**Halton District School Board
RFT 25-061 School Renovation Project - Paul A Fisher PS**

Addendum No. 1

PROJECT NO. 24131
HOSSACK ARCHITECTURE

ADDENDUM NO. 1

ROOF FRAMING PLAN - PROPOSED

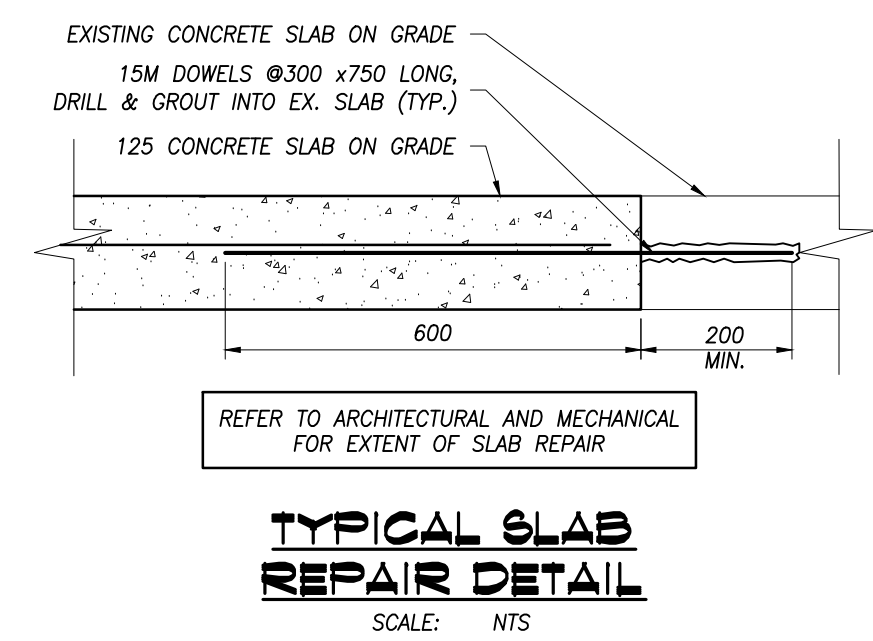
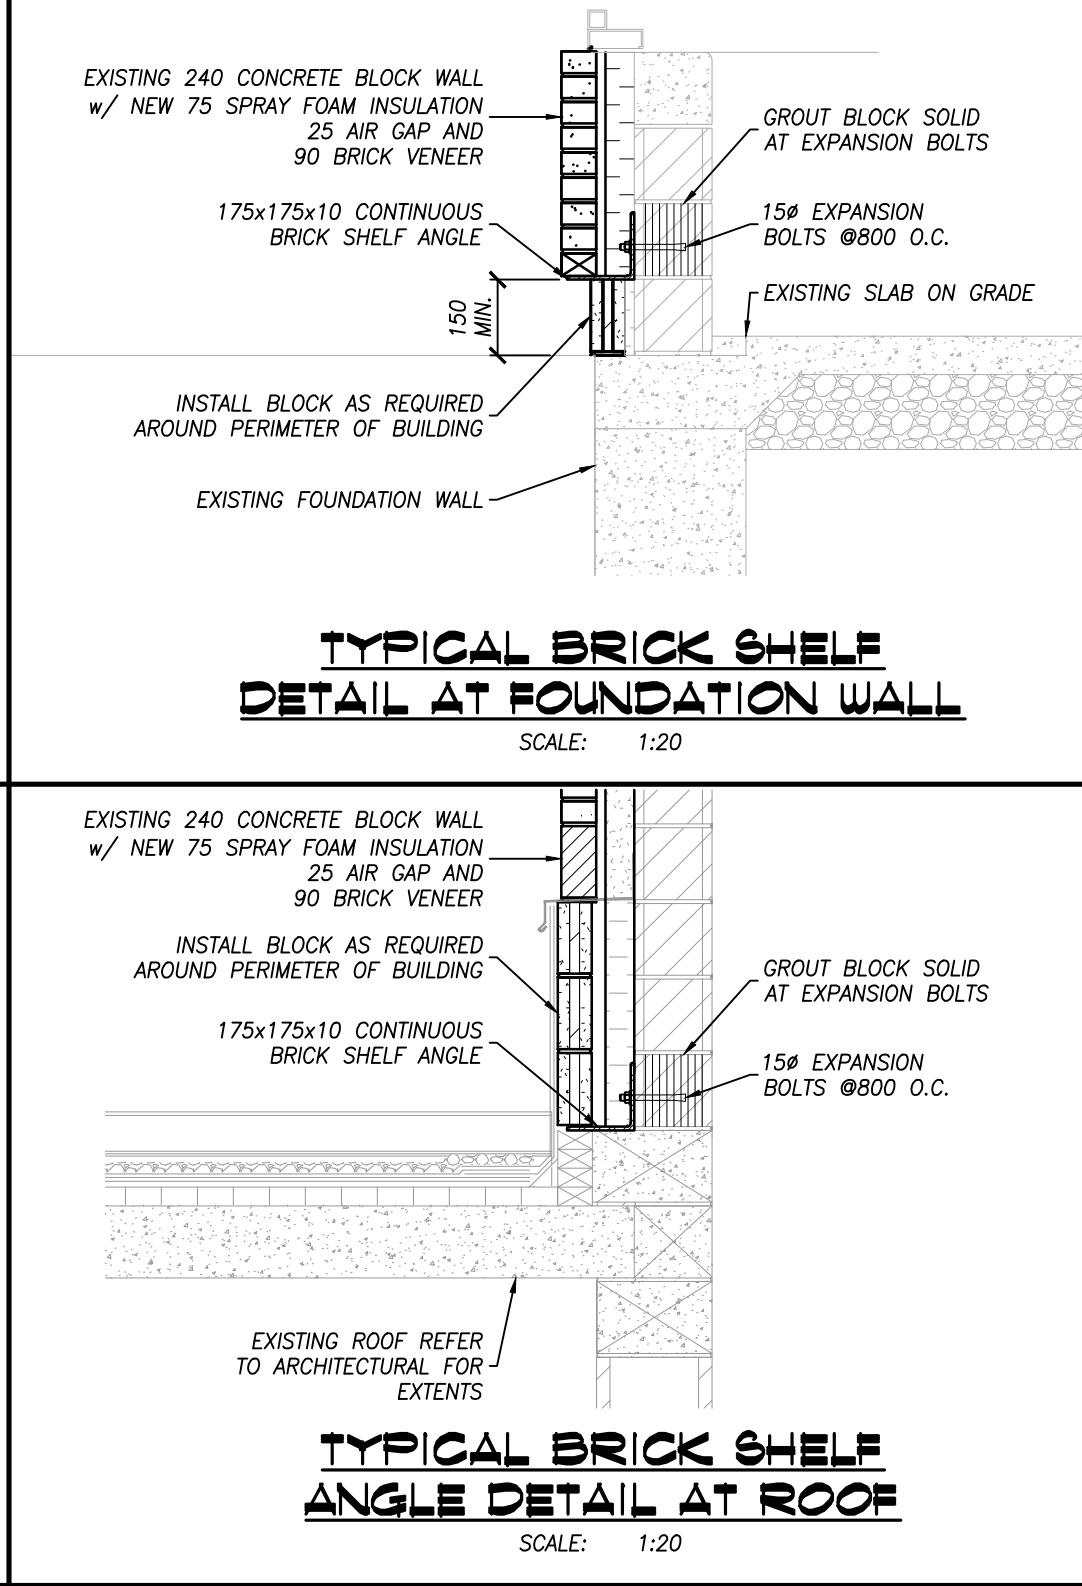
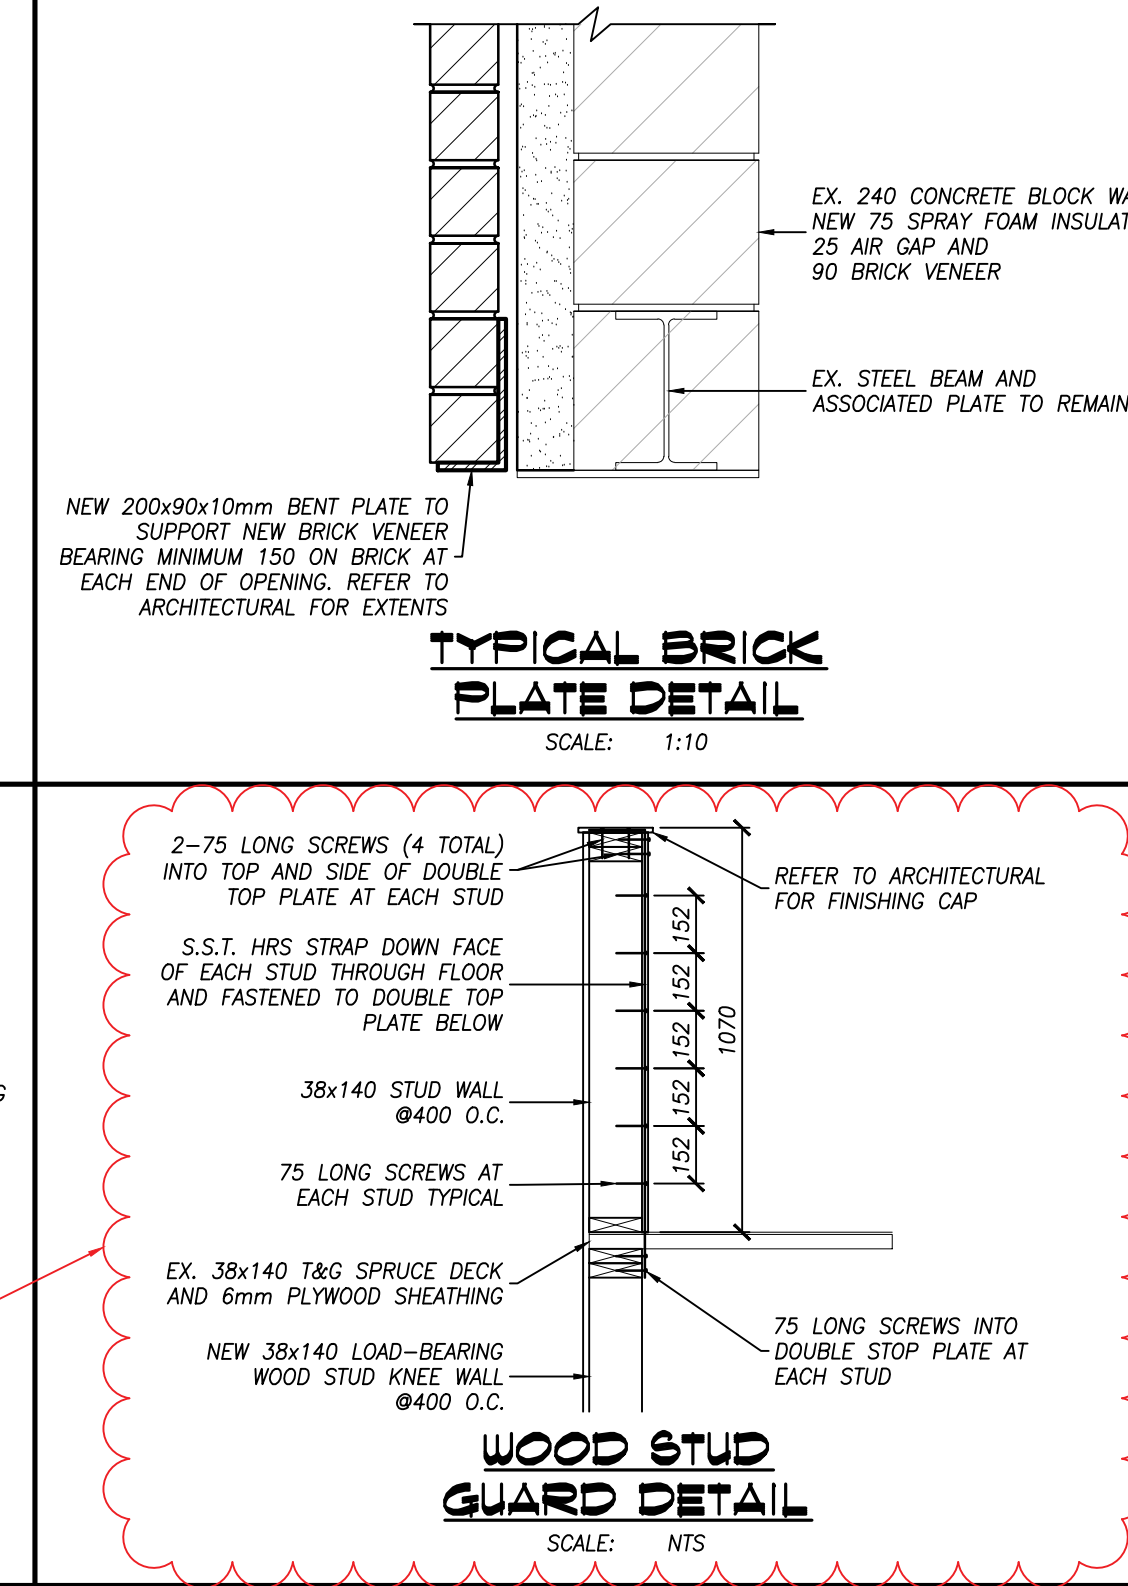
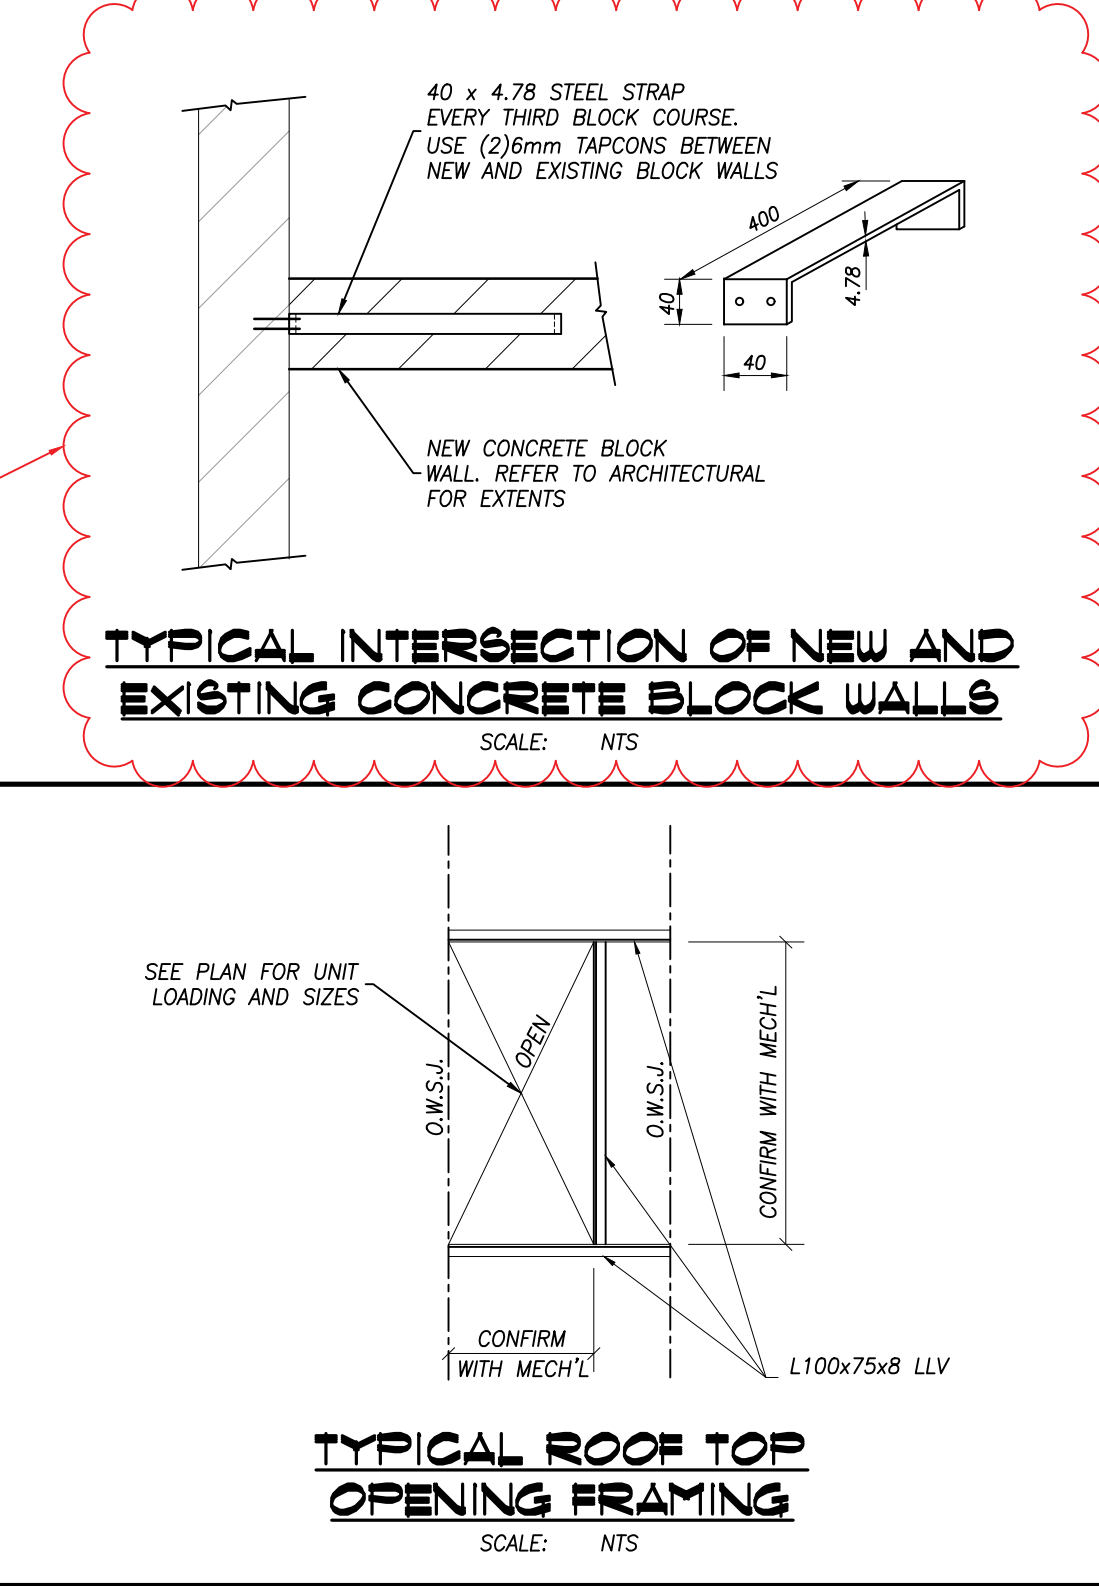
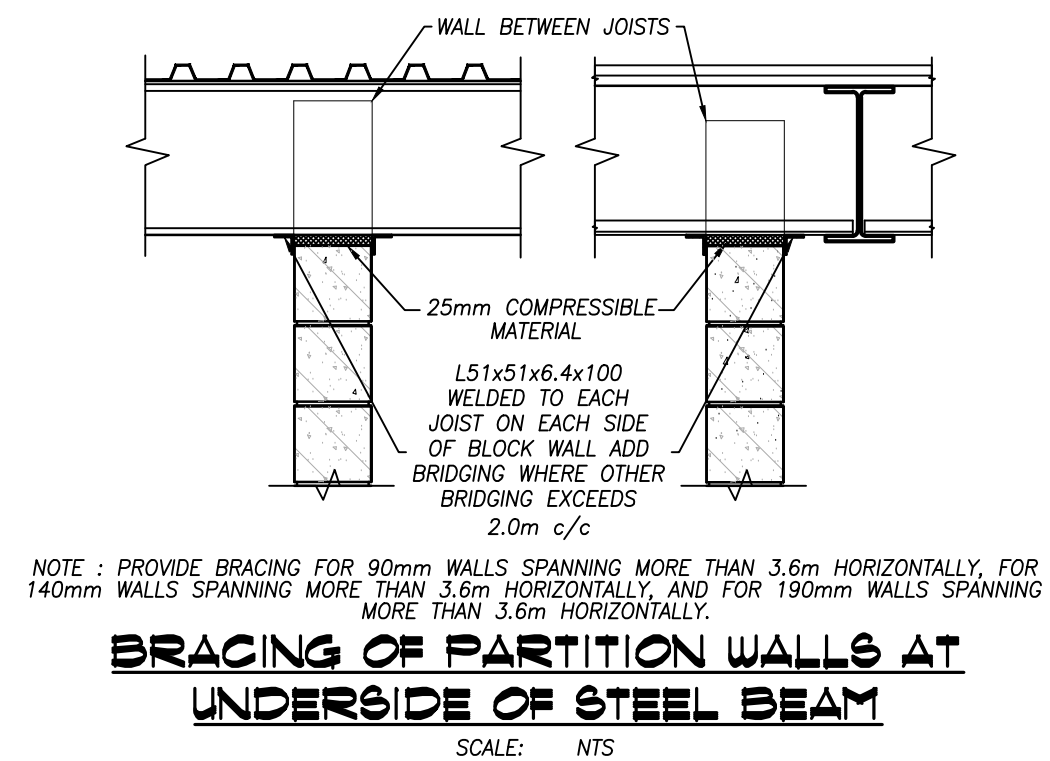
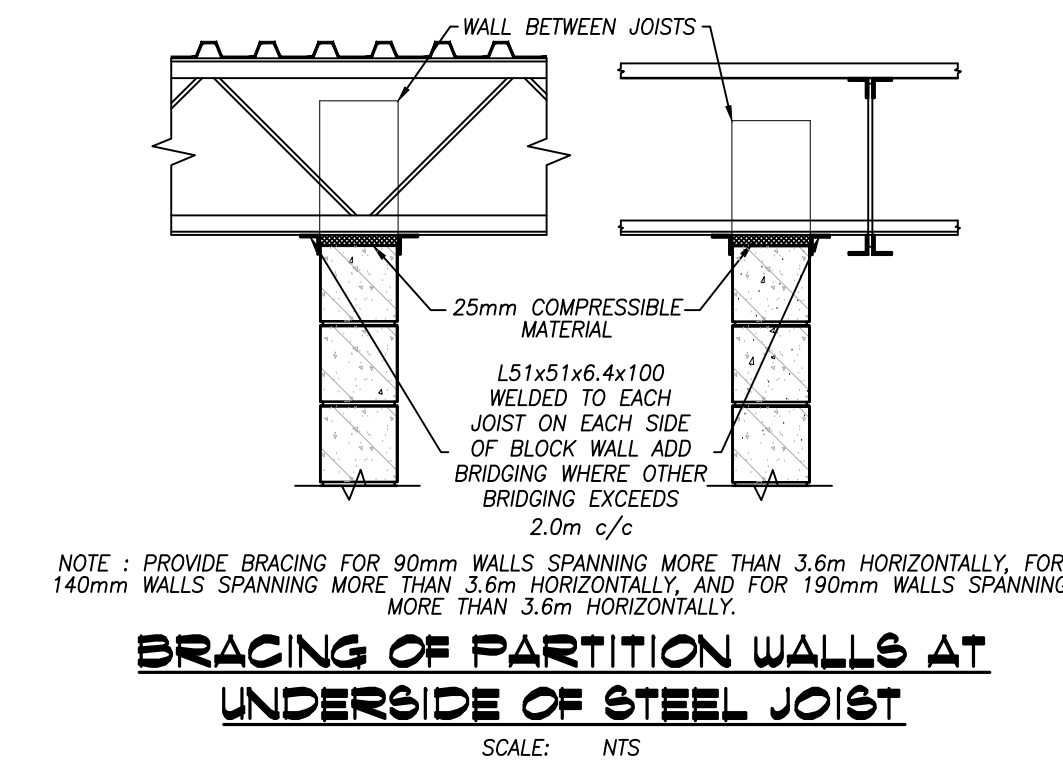
Item 10: S1.1 Roof Framing Plan - Proposed

- A. Refer to [Drawing S1.1]:
 - Added new note C6.
 - Added new general note regarding brick ties.
- B. Refer to [Drawing S2.0]:
 - Added new detail for typical intersection of new and existing concrete block walls.
 - Edited the height of wood stud on the wood stud guard detail.

- .1 REPLACE Drawing with revised S1.1 included in attached Structural Addendum #1.

TYPICAL FRAMING DETAILS & SECTIONS

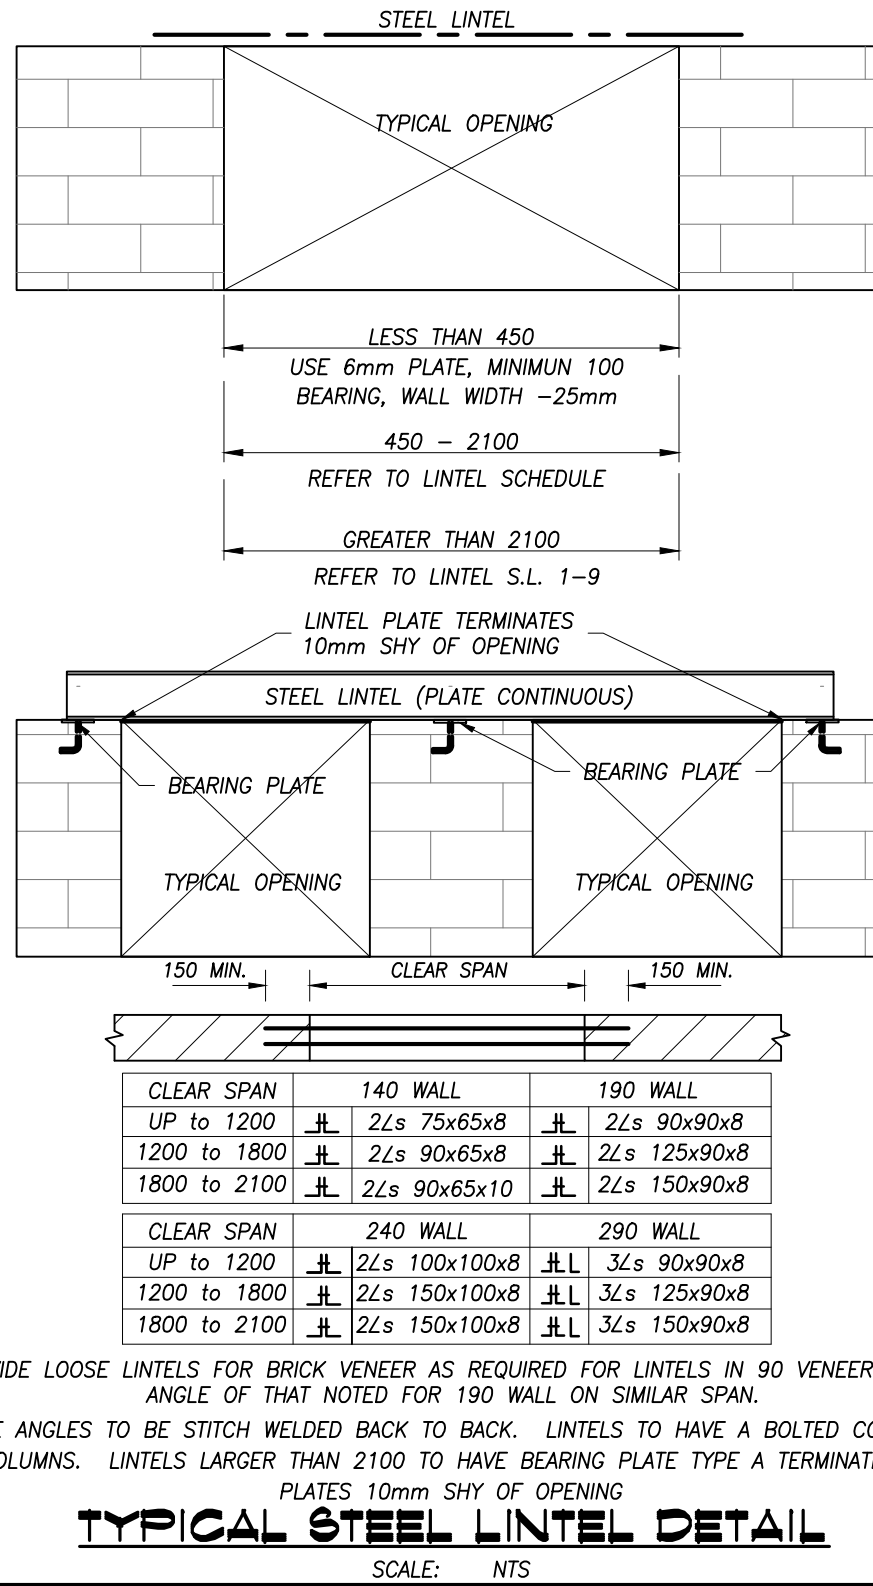
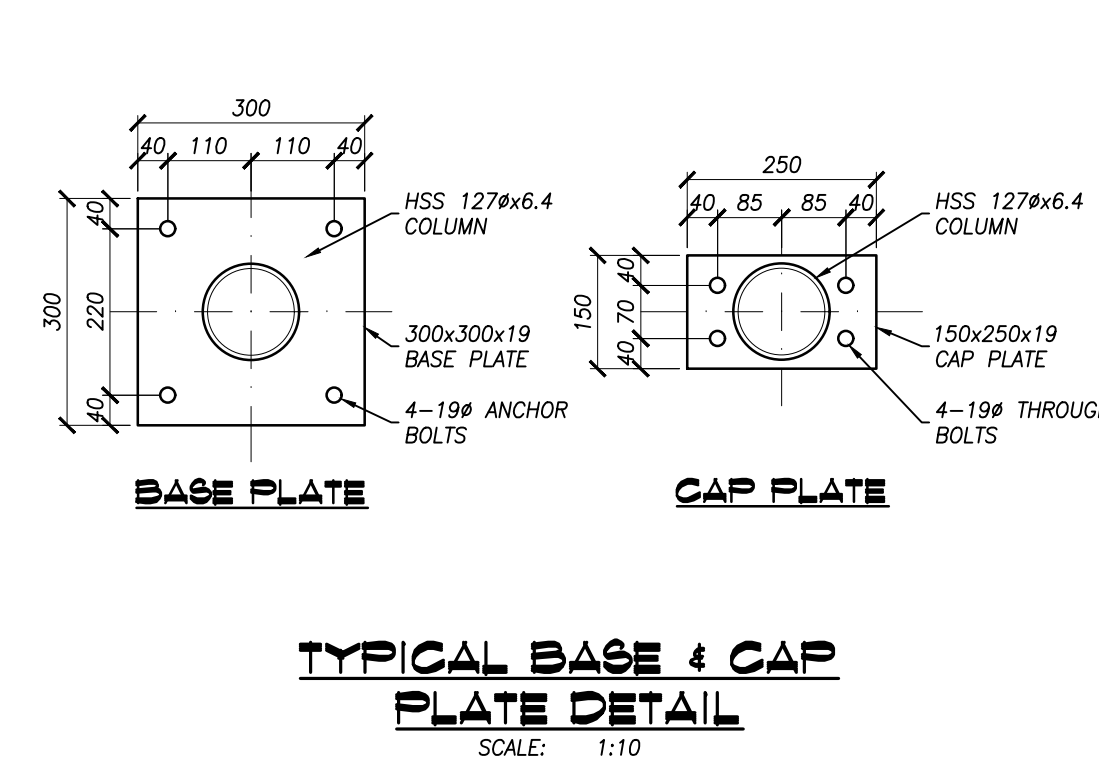
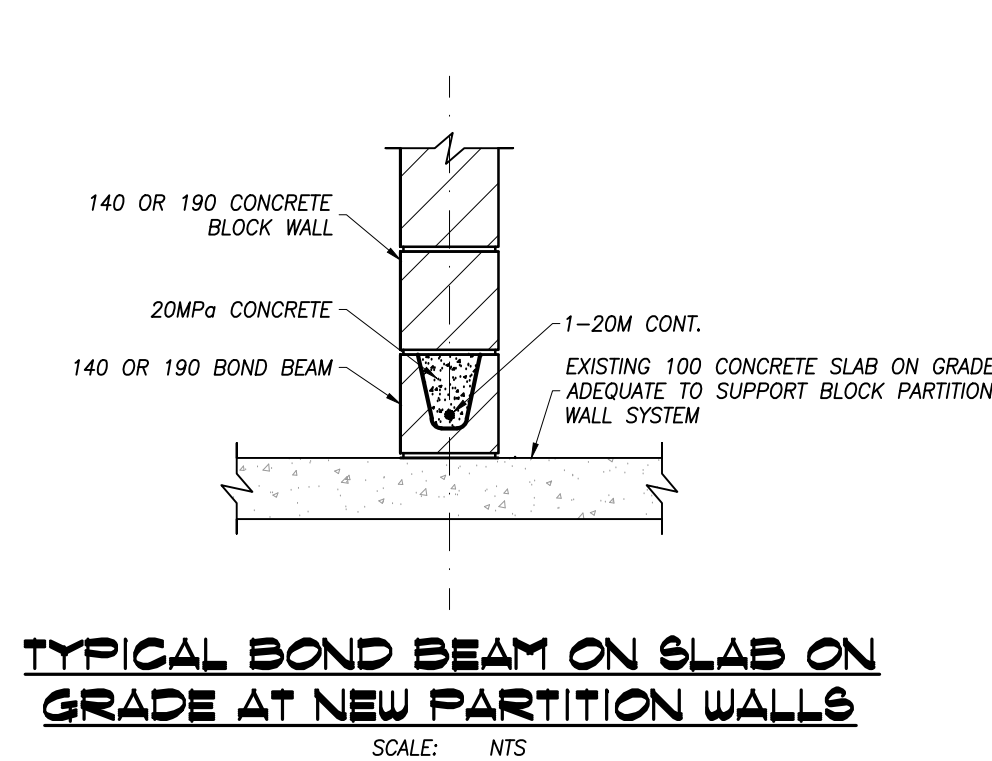
Item 11: S2.0 Typical Framing Details & Sections

- .1 REPLACE Drawing with revised S2.0 included in attached Structural Addendum #1.
